DATE: March 7, 2024
TO: Potential Respondents
FROM: Carrie Stoeckert—Senior Construction Contract Coordinator
SUBJECT: Questions #1
RFCSP752-24-983CS
UNT DATCU Stadium Chairback Seating

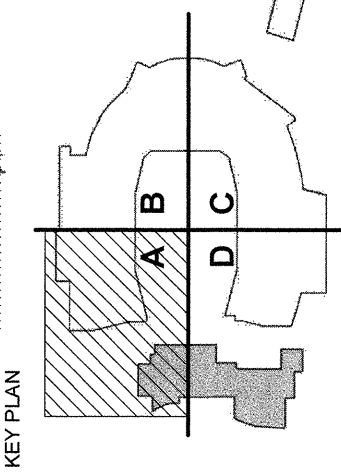
10. Regarding Exhibit F, assumption is this detail applies to the available tread depth for all proposed improvements for the Chairback Seating, Leaning Rail with Cup Holders, and Stadium Type Drink Rail are proposed, is that correct?

ANSWER: **Tread depth is consistent throughout the stadium**
